CALIFORNIA DEPARTMENT OF FISH AND WILDLIFE

AMENDMENT NO. 1
(A Major Amendment)
California Endangered Species Act
Incidental Take Permit No. 2081-2020-043-04
Southern California Gas Company
Line 85 Milepost 75.75/75.94 Pipe Recoat Project in Kern County

Figure 2a: Project Location Detailed Map

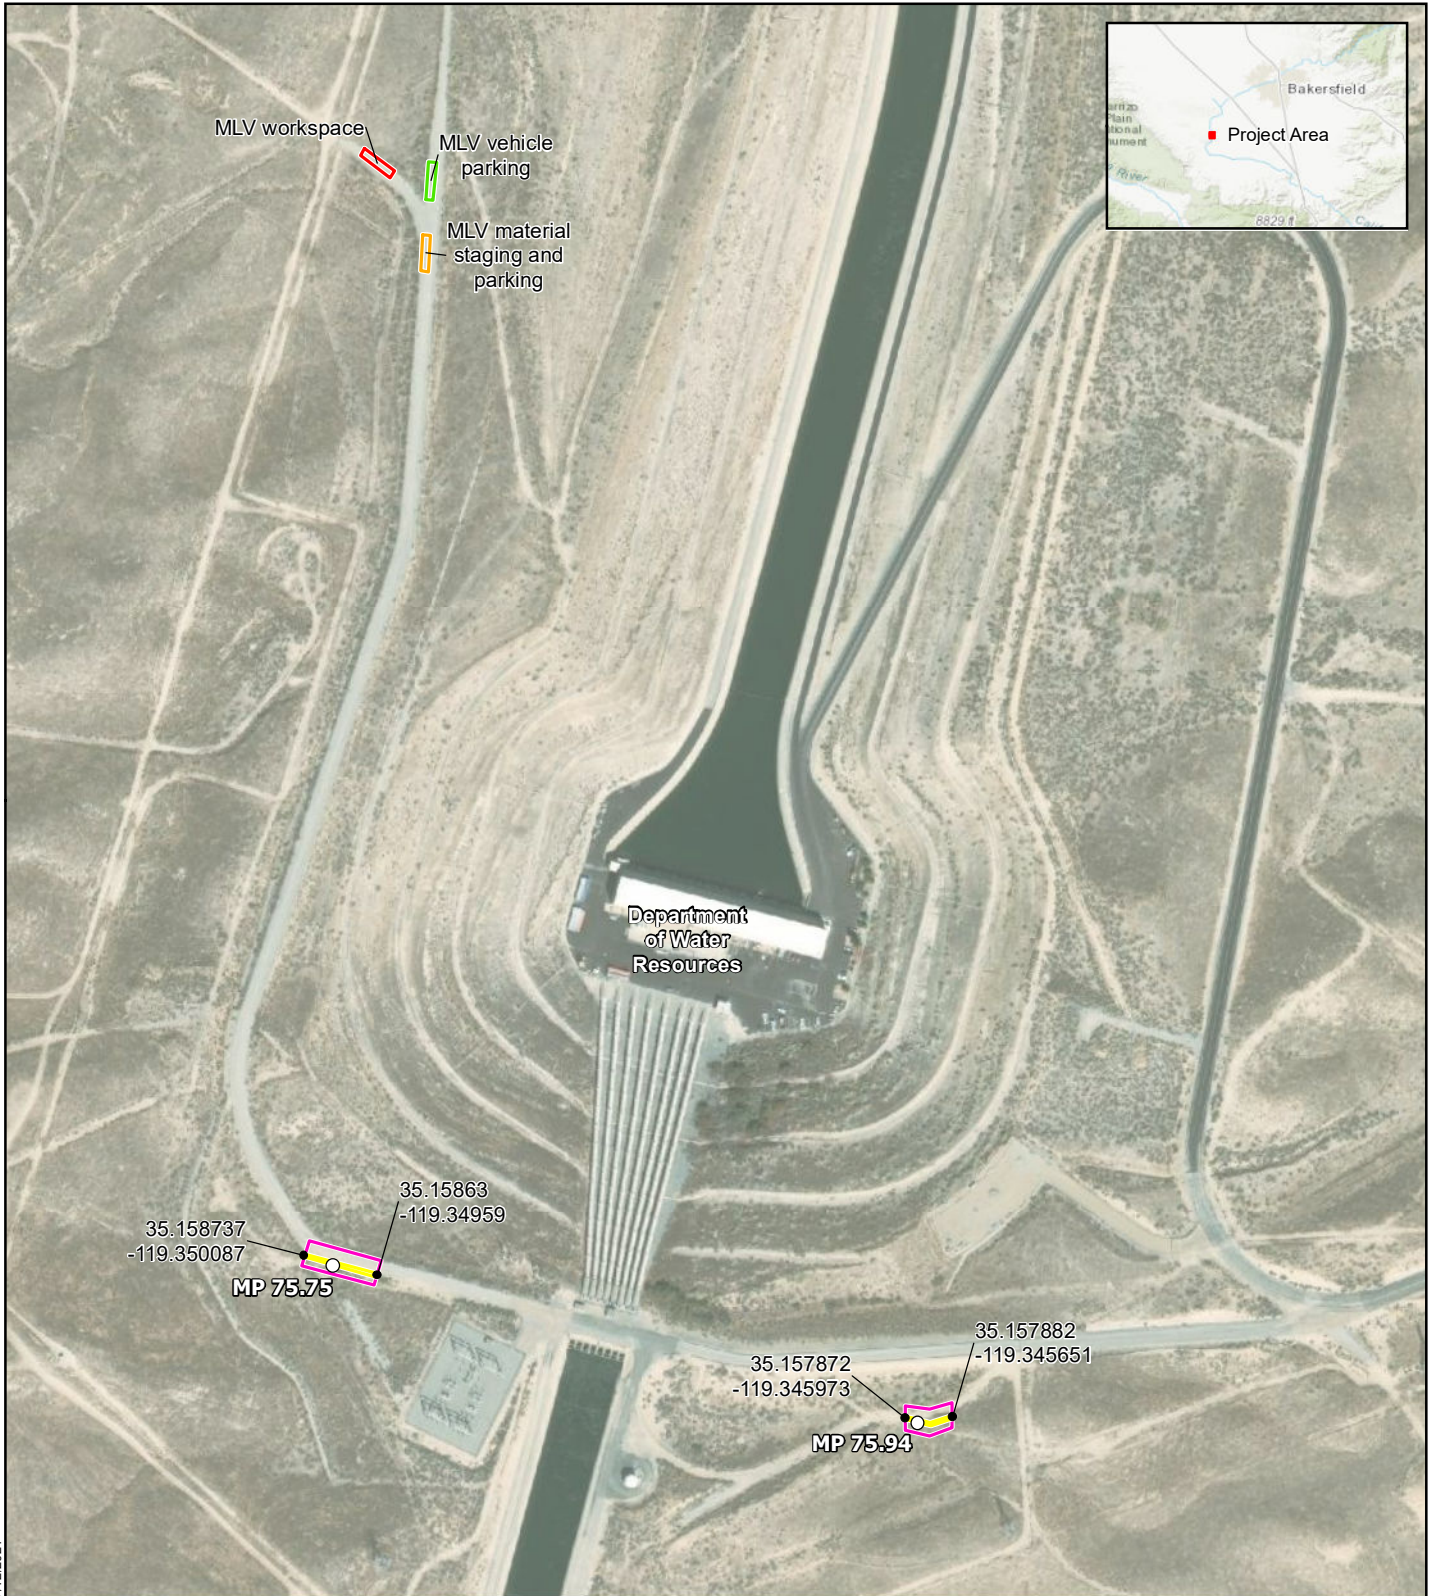
First, this Amendment modifies the Project Area to add an additional Work Area located north and west of the two existing inspection and repair locations. The additional Work Area will need to be excavated to fully expose the pipeline for MLV installation.

Third, this Amendment adds a Staging Area and a Vehicle Parking Area to the Project Description.

Fourth, this Amendment reduces the footprint of the Work Area east of the California Aqueduct to 95 feet long by 50 feet wide.

Sixth, this Amendment revises and accordingly replaces Figure 2 of the ITP with Figure 2a to depict the additional Work Area, Staging Area, and a Vehicle Parking Area within the modified Project Area.

The Line 85 Milepost 75.75/75.94 Pipe Recoat Project (Project) is located in the southern San Joaquin Valley approximately 5.5 miles east of the town of Taft in Kern County, California (Figure 1). The Project is specifically located on California Department of Water Resources-owned land adjacent to and on both sides of the California Aqueduct near Lake Station Road within the United States Geological Survey 7.5-Minute Quadrangle Map Buena Vista Lake Bed in Township 32 South, Range 24 East, Section 12, Mount Diablo Base and Meridian; Latitude 35.158737, Longitude -119.350087, ~~and~~ Latitude 35.157882, Longitude -119.345651, ***and Latitude 35.164858, Longitude -119.349671*** (Figure ~~2~~***2a***).
